STAFF REPORT
(One-Step Final Plat)

CASE NUMBER: S/D 00-21 -- LORAC FIRST ADDITION

VICINITY MAP

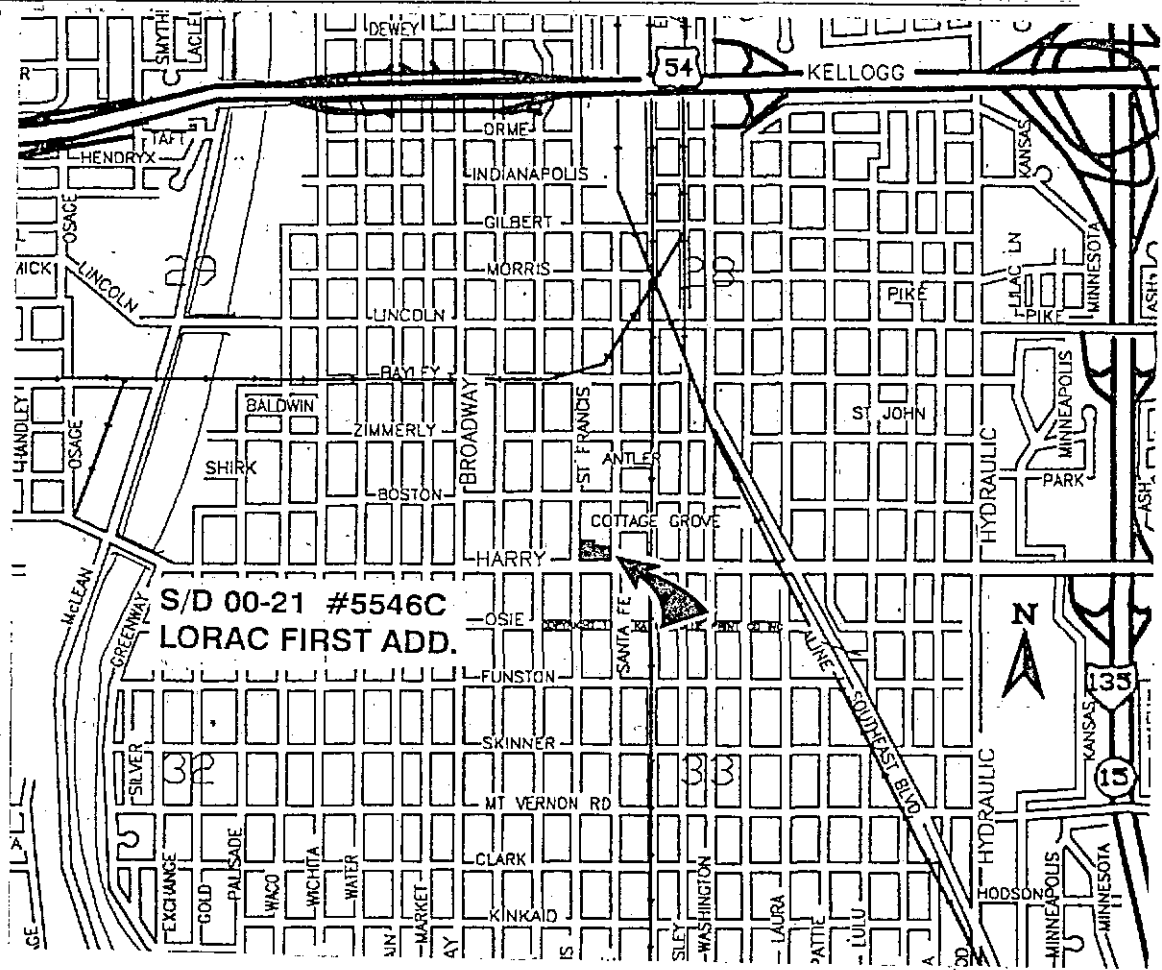
*Sewer under
the building*
